**JOINT REGIONAL PLANNING PANEL
(Sydney East Region)**

JRPP No	2015SYE002
DA Number	LDA2014/0517
Local Government Area	City of Ryde
Proposed Development	Mixed use development containing 380 apartments, retail premises and car parking for 366 vehicles, and landscaping works
Street Address	1-17 Delhi Road, North Ryde
Applicant	Australand North Ryde Development Pty Ltd
Number of Submissions	1 submission objecting to the development
Regional Development Criteria (Schedule 4A of the Act)	General Development over \$20 Million
List of All Relevant S79C(1)(a) Matters	<ul style="list-style-type: none"> • State Environmental Planning Policy (State and Regional Development) 2011 • State Environmental Planning Policy No. 55 (Remediation of Land) • State Environmental Planning Policy (Building Sustainability Index: BASIX) • State Environmental Planning Policy No. 65 – Design Quality of Residential Flat Development • State Environmental Planning Policy (Infrastructure) 2007 • Deemed State Environmental Planning Policy Sydney Regional Environmental Plan (Sydney Harbour Catchment) 2005 • Ryde Local Environmental Plan 2014 • Draft State Environmental Planning Policy No 65 – Design Quality of Resid

Figure 9. Location of the retail tenancy along Delhi Road in front of Buildings C and D.

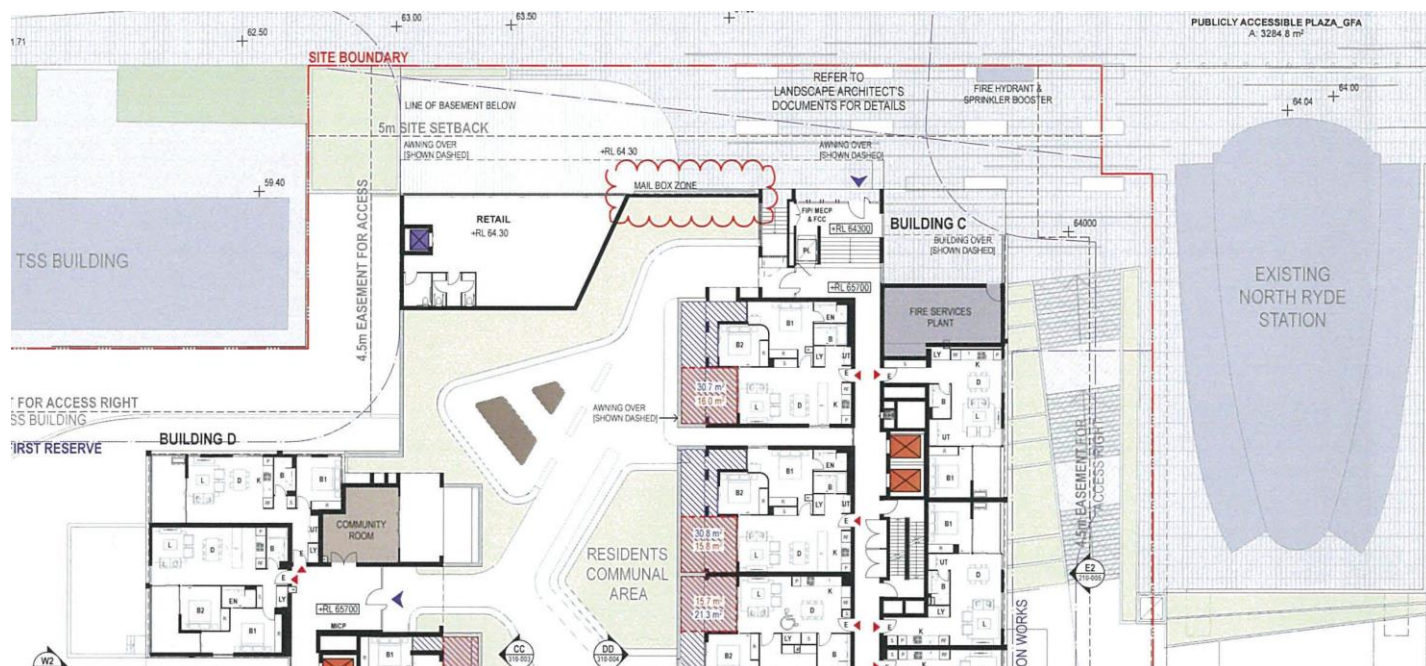
The retail pavilion on Delhi Road appears isolated from both the station entry and the new plaza, as such its potential for success seems limited. The Panel supports the notion that retail would be better situated close to the station entry, and concentrated around the plaza edges.

Comment: The below figure demonstrates the location of the retail space in question. This location is considered suitable for retail activity given that there will be a considerable amount of pedestrian traffic walking in front of the site via the new pedestrian bridge which connects the rest of the North Ryde Station Precinct.

Figure 10. Ground floor of western podium demonstrating the relationship with Station Street and the easement to the western Chatswood Rail Link building.

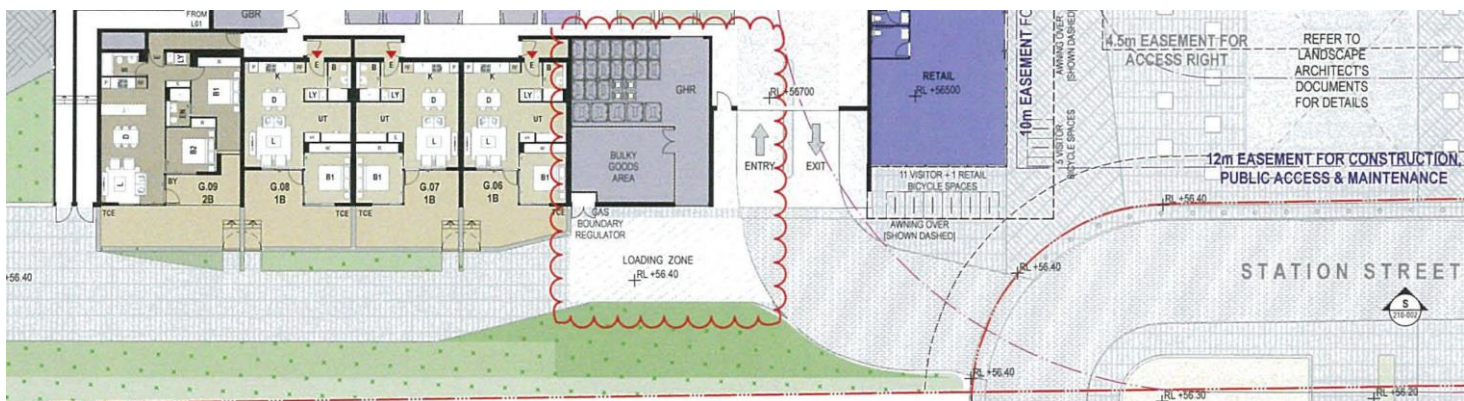
The Panel also considers that the stub road to the service building to the east should be designed as a two way 'street' that provides the same character and quality of a traditional street including street trees and landscape and that provides an appropriate address for the ground floor units. Such a street would also better address the ground floor apartments opposite in the Country Garden development.

Comment: The following figure demonstrates the location of the stub road as referred to by the Panel. The applicant has advised that the stub road is actually an easement for access to the western Chatswood Rail Link building. The easement is required to be accessible by heavy vehicles and cranes for maintenance and must be free of buildings, structures or hindrances. If this was provided as a road it would be necessary to provide a turning area for vehicles. This would occupy a significant area of the site as well as resulting in conflict with service vehicles. The provision of a street as suggested by the Panel is not supported.

Figure 11. Secondary access to the development has been provided via a new residential foyer that can be accessed from the Plaza.

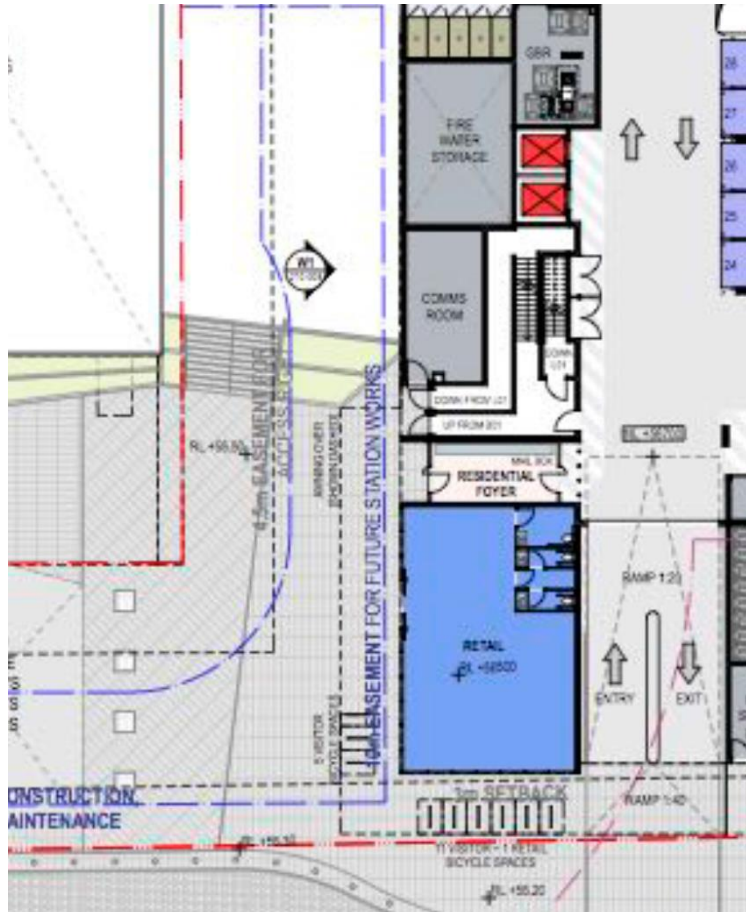
The Panel does not support single entry points for each building cluster. Additional entry points should be provided to provide a range of access opportunities for residents and to provide clear address and way finding for visitors and tradesmen or deliverymen. To achieve this, the Panel considers that additional entries to the cores should be provided from the plaza at the lower level or from Station Street into the building. For the eastern building cluster an entry point should also be provided from Road 38 into the eastern most tower from that street. It is noted that additional building cores may be required to achieve this outcome.

Comment: The amended plans have incorporated a new residential foyer off the plaza into each of the buildings. From the new foyers it will be necessary to access the car parking area on the ground floor to gain access to the lift cores. This is demonstrated on the following plan. While the main address of the site is Delhi Road, the amended plans have proposed improved residential access to the site via the plaza area. This is considered to satisfy the concern raised by the Panel.

Figure 13. Typical floorplan demonstrating the 'snorkel' apartment.

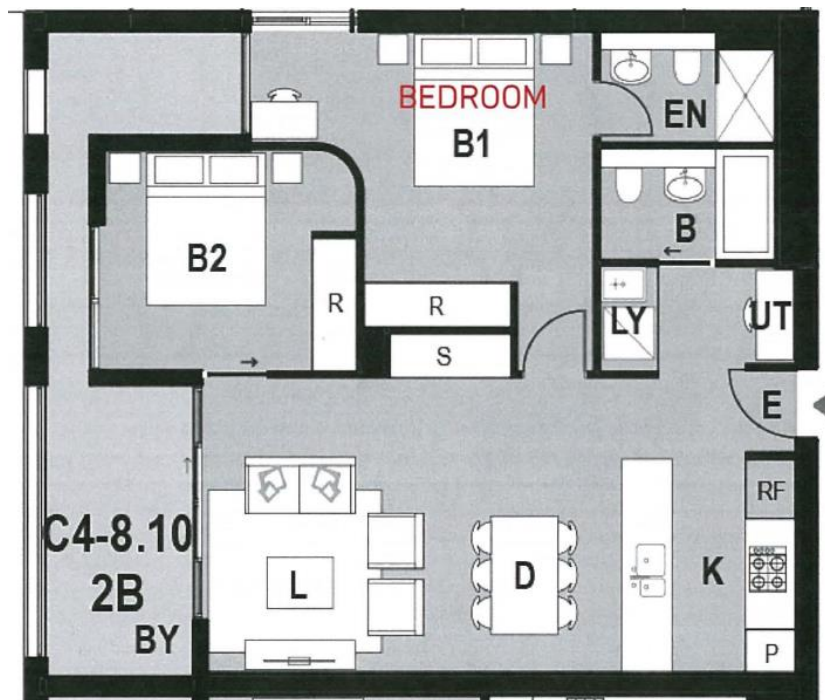
The Panel notes from the preliminary plans that a number of units rely on bedroom windows deeply recessed into the plan with narrow outlooks. The panel does not support this approach and the plans should be further developed to ensure all bedrooms benefit from a reasonable outlook, light and ventilation via a reasonable width of façade.

Comment: The development has incorporated 80 apartments that are defined as 'snorkel' apartments. The following figure demonstrates a typical layout of the apartments.

The apartments in question are all restricted to the main bedroom which are larger in size than the secondary bedrooms. Each of the bedrooms have a full height window with a width of 1.5m. Some of these apartments open up directly onto a balcony and some have secondary windows. While in many cases it would be possible to delete the 'snorkel' component of the apartment, this would only result in the bedroom having less amenity. These apartments have been utilised throughout Sydney. As proposed the snorkel contributes to the amenity of the apartments and it is recommended that it remains.
